DOCUMENT NUMBER: 17-00175
 ISSUE NUMBER: 2
 ISSUE DATE: February, '98

RELATED DOCUMENTS:
 C/R 25243
 17-00180

9323/9360/9390/9680/9780 lock up

Figure 1: Location of components

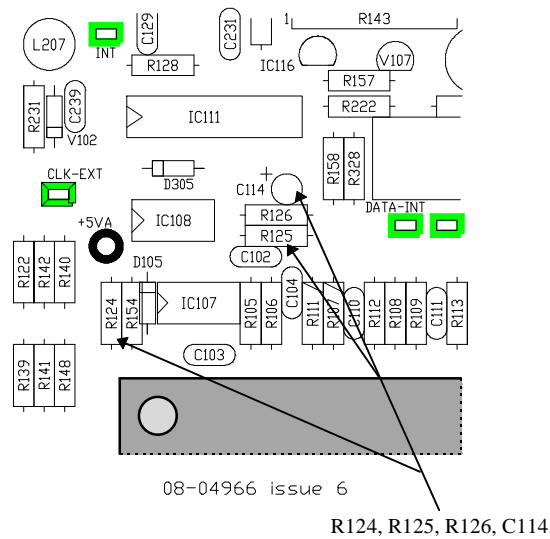
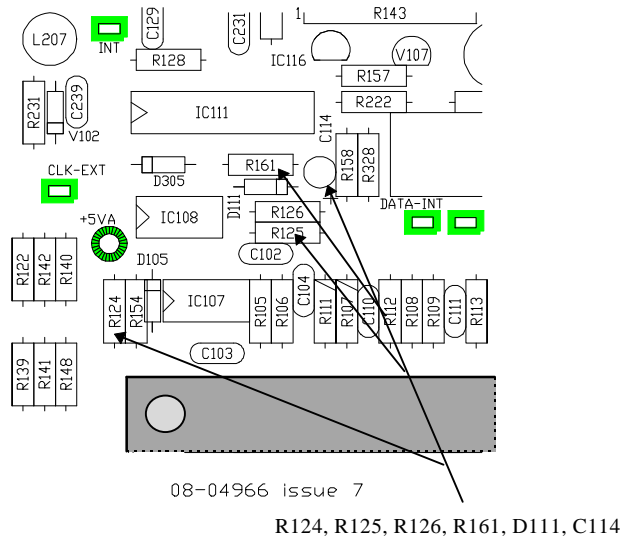
- Remove the transceiver (including the control head where applicable) from the installation.
- Remove the two screws securing the bottom cover and remove the cover.
- Locate the Microprocessor and Audio Assembly PCB (Printed Circuit Board), 08-04966-001.
- Disconnect all the ribbon cables from the PCB taking careful note of the orientation of the connectors on P103 and P302.
- Remove the eight screws securing the PCB.
- Withdraw the PCB from the chassis.
- Locate and remove R124, R125, R126, and C114. Refer to Figures 1 and 2.

- Remove R161 and D111 if fitted. Refer to Figures 1 and 2.
- Locate IC107 (LM358). Refer to Figure 3.

Figure 3: Location of IC and 47 kΩ resistor

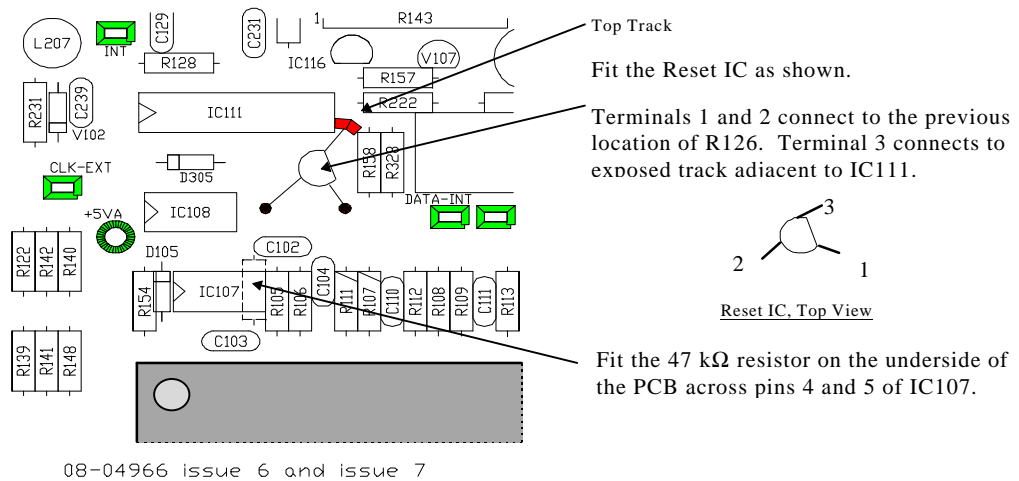
- Fit and solder the 47 kΩ resistor across pins 4 and 5 of IC107. This is best done on the underside. Refer to Figure 3.
- Locate the track on the component side of the PCB adjacent to IC111. Refer to Figure 3.
- Using the scalpel or blade, carefully scrape the green masking from the track so that approximately 2 mm of bare copper is exposed.
- Tin the exposed copper.
- Fit the Reset IC as shown in Figure 3.
- Fit and secure the PCB into the chassis with the eight screws.
- Replace all ribbon cables onto their corresponding connectors paying particular attention to the orientation of P103 and P302.

**Figure 4: Location of components****Figure 5: Location of components**

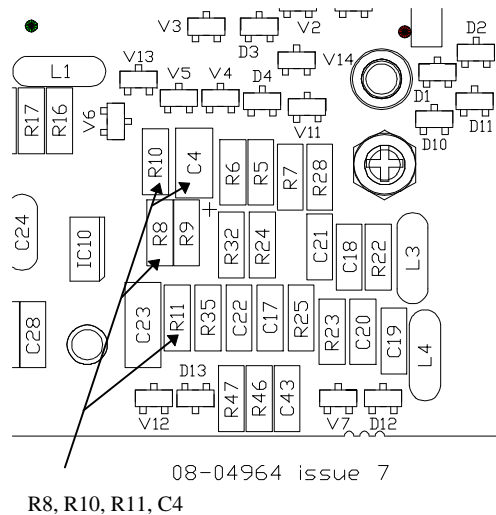
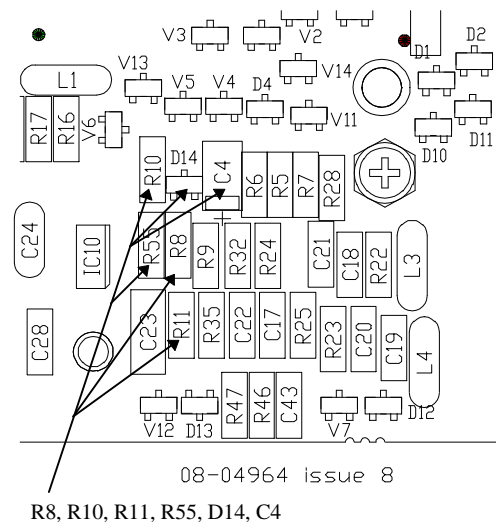
- Locate R8, R10, R11, and C4. Refer to Figures 4 and 5.

- Using a pair of tweezers (or small nose pliers) and soldering iron, or a SMD desoldering tool, remove R8, R10, R11, and C4 from the PCB.
- Remove R55 and D14 if fitted. Refer to Figures 4 and 5.
- Fit and solder the 47 kΩ resistor as shown in Figure 6 or 7.

Figure 6: Location of IC and 47 kΩ resistor

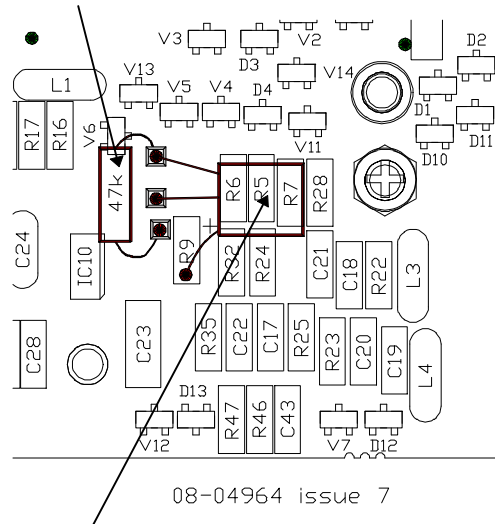
Fit 47 kΩ resistor between R8 and R10 pads as shown

Fit Reset IC to, R10 pads and to R9—**Flat side UP**

Figure 7: Location of IC and 47 kΩ resistor

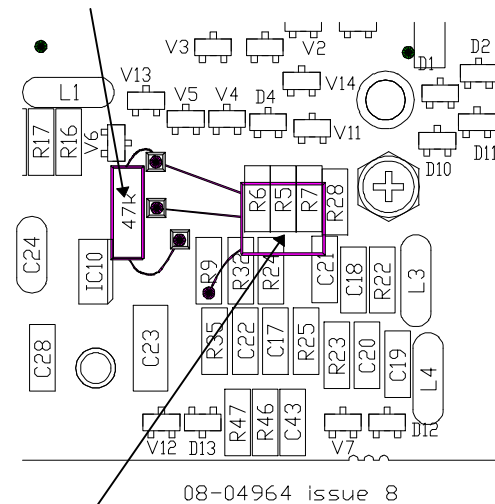
Fit 47 kΩ resistor between R8 and R10 pads as shown

Fit Reset IC to, R10 pads and to R9—**Flat side UP**
